2CAN111301

SUBJECT: Response to Request for Additional Information  
Adoption of National Fire Protection Association Standard NFPA-805  
Arkansas Nuclear One, Unit 2  
Docket No. 50-368  
License No. NPF-6

**Responses to Request for Additional Information  
ANO-2 Transition to NFPA-805**

**Figure 1**  
Simplified HRA for FPRA Operator Actions In-Control Room Flowchart

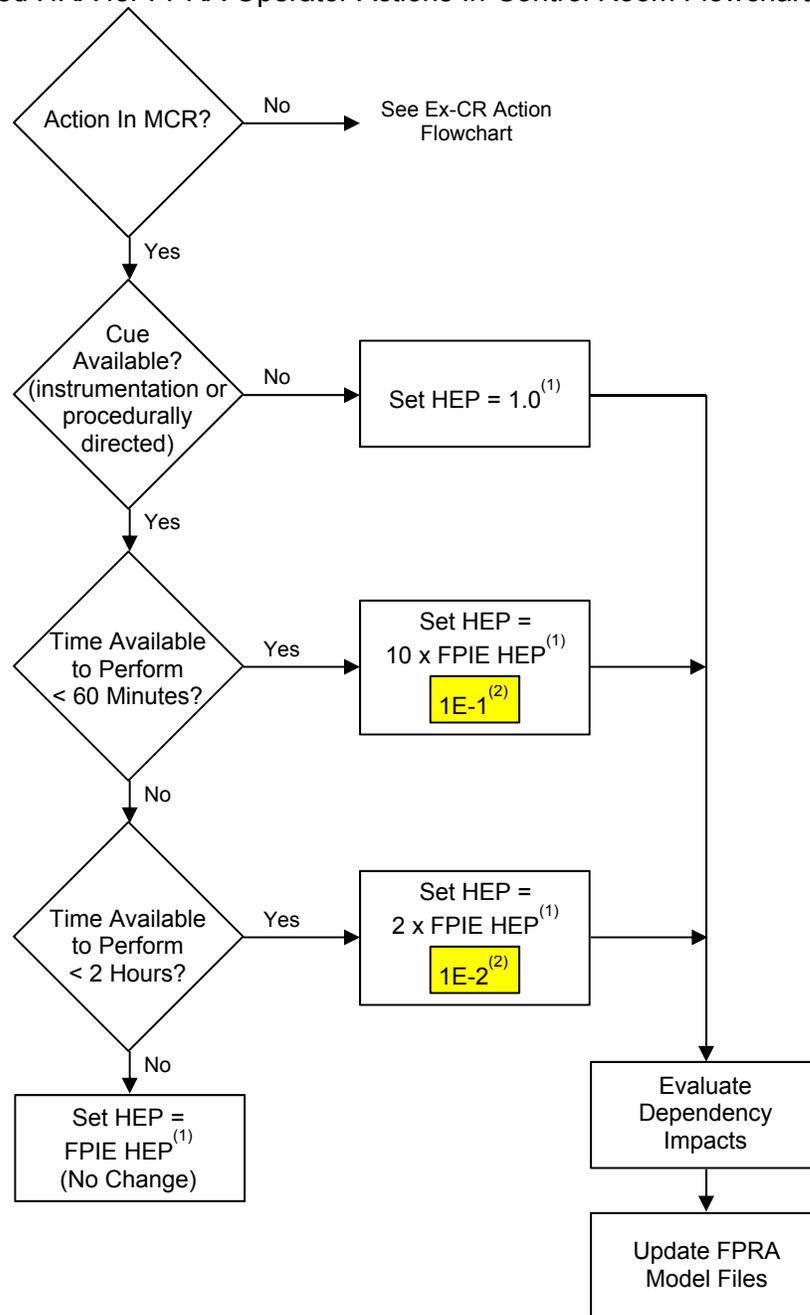
As indicated in Note 4 of the In-Control Room Flowchart (Figure 1), "actions such as immediate memorized response actions, may not require adjustment." Actions that meet this criterion are annotated in the evaluation.

Figure 1-1 – HRA Timeline

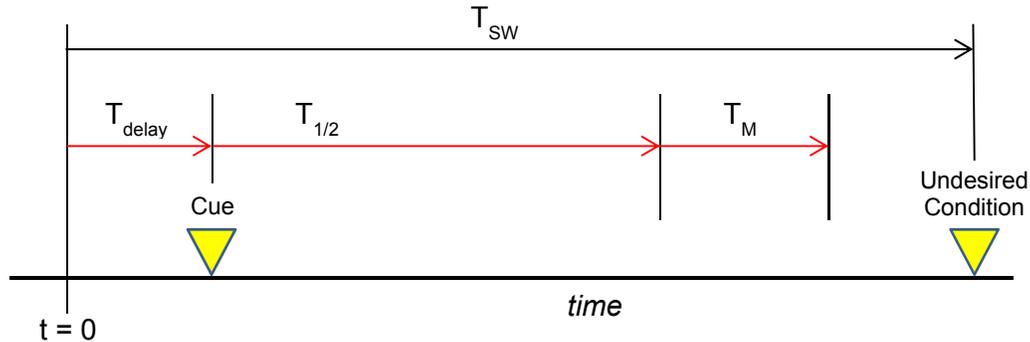
In the Cause-Based Decision Tree Method (CBDTM) and the Human Cognitive Reliability - Operator Reliability Experiment (HCR-ORE) Method in the HRA Toolbox, timing is evaluated with the use of a timeline (illustrated conceptually in Figure 1-1<sup>2</sup>) and the following key time parameters which will be adjusted as indicated to account for fire impacts.

Figure 1-4 – CBDTM Decision Tree Pc-b

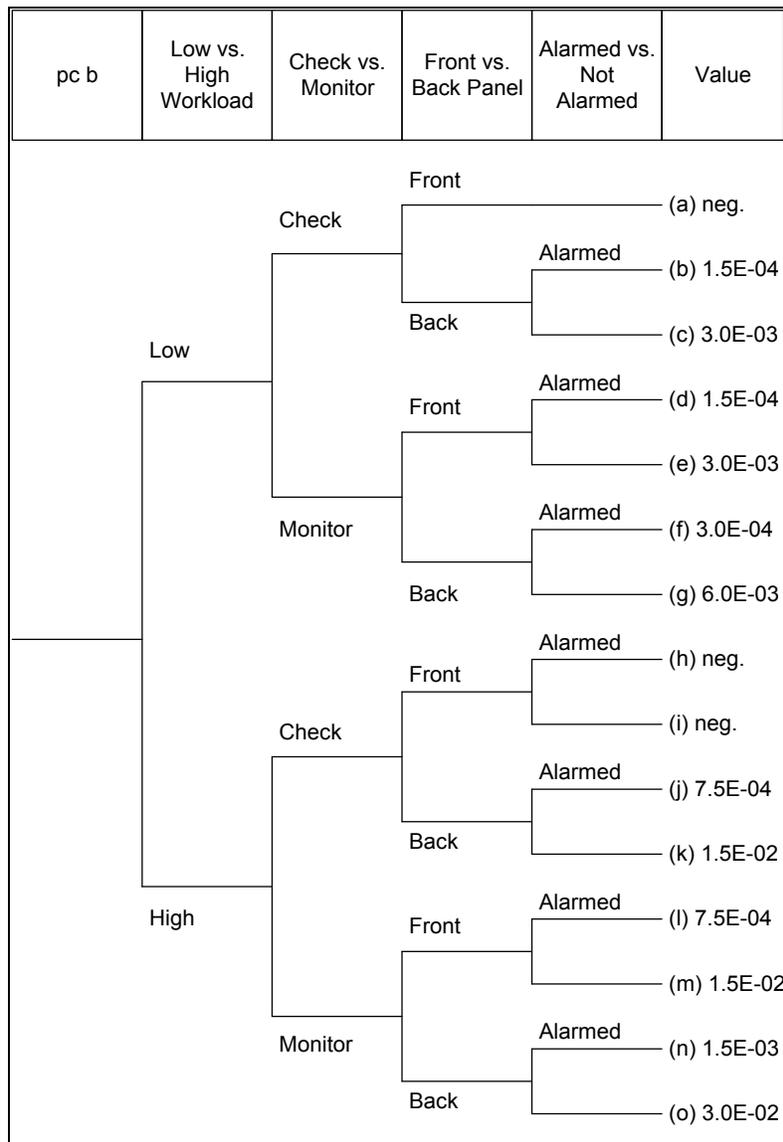
Workload impacts are modeled explicitly in CBDTM decision tree Pc-b (Figure 1-4) as part of the cognitive phase (detection and diagnosis). If fire causes an increase in workload, the branch of the decision tree for high workload is selected. There is the potential for intra-crew recovery if additional staff is available, but a higher dependency is usually set for these intra-crew recovery actions than for internal events HEPs.

Figure 1-5 – Multiple Procedures Branch in CBDTM Decision Tree Pc-e

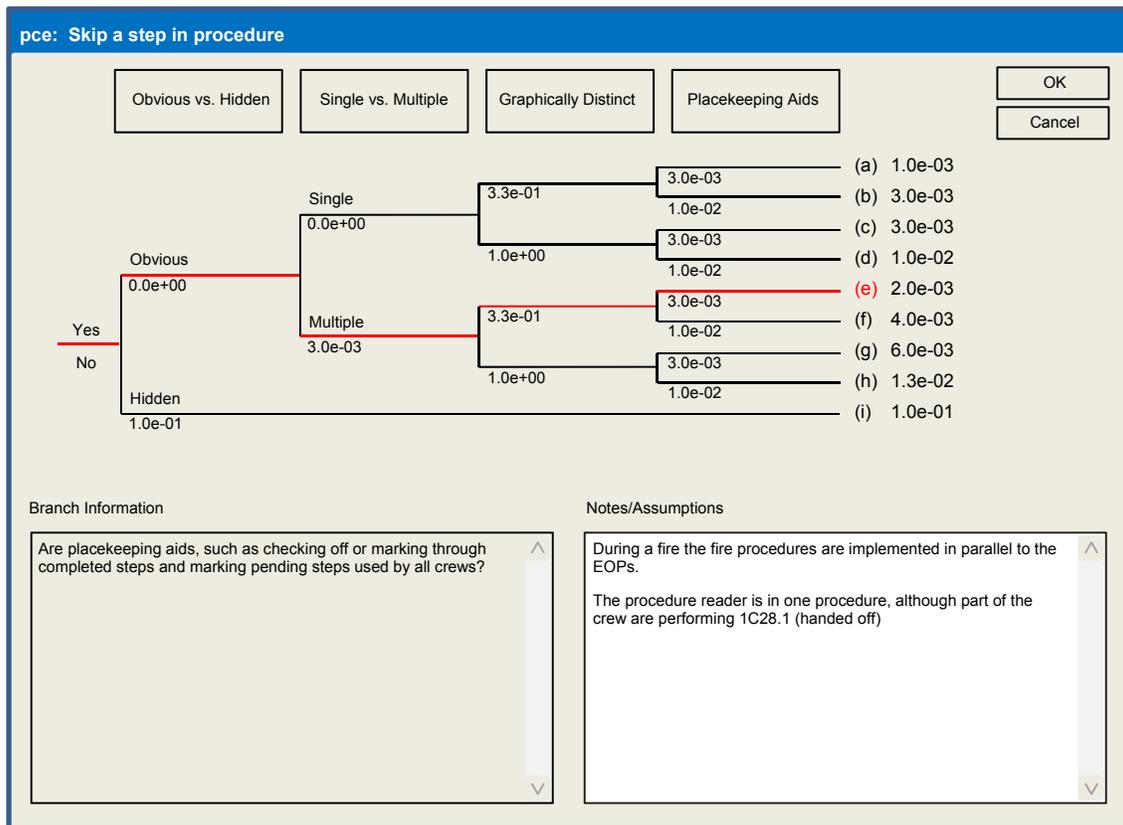
If emergency operating procedures (EOPs) and abnormal operating procedures (AOPs) are implemented in parallel to the fire procedures (a subset of the AOPs at ANO), then the multiple procedures branch in CBDTM decision tree Pc-e is selected (Figure 1-5). If EOPs/AOPs are not in use while fire procedures are being used, then only one procedure is credited and any time delays are accounted for in the timeline. Therefore, while a fire is likely to involve multiple procedures at ANO, any exceptions are appropriately addressed.

Figure 1-6 – Execution Stress in CBDTM THERP Module

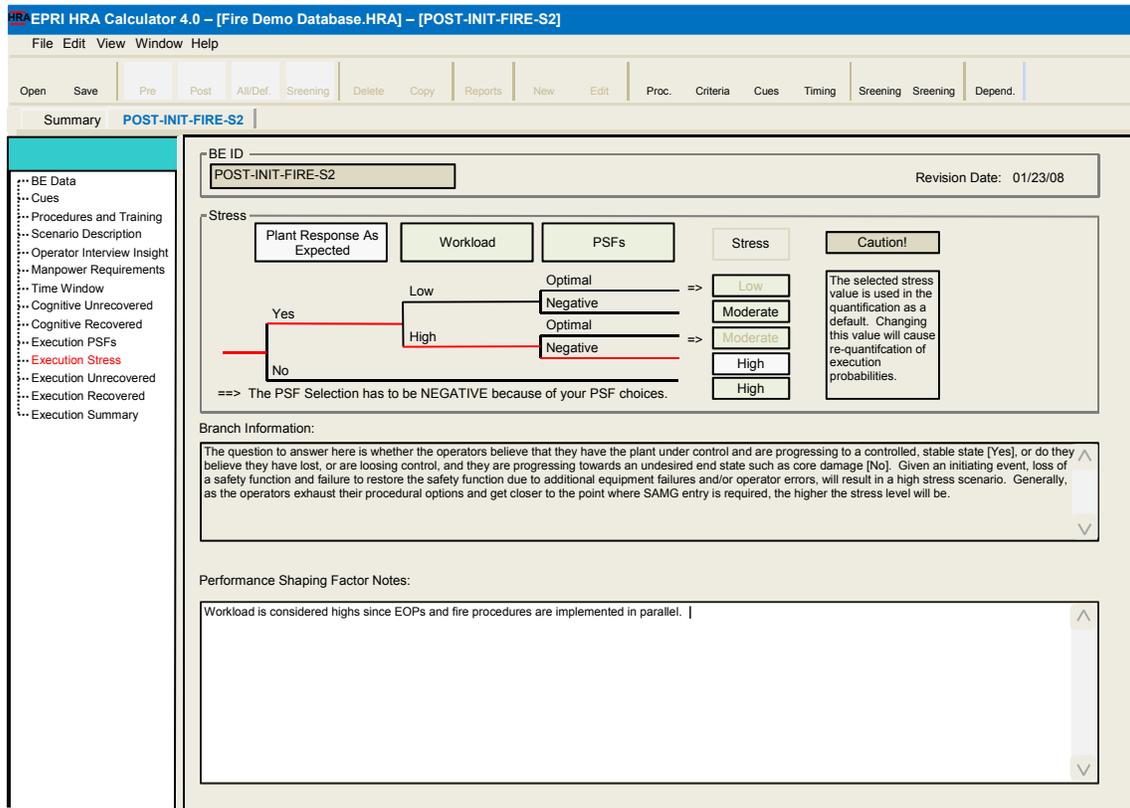
In the HRA Toolbox, task execution errors are addressed using THERP. For fire, if the execution stress is less than high then it is increased from the internal events case using decision tree Pc-e shown in Figure 1-6, except for Control Room actions when Operator actions occur more than 70 minutes after the fire has started, because 99% of fires are extinguished within 70 minutes per the fire event data documented in FAQ 08-0050.
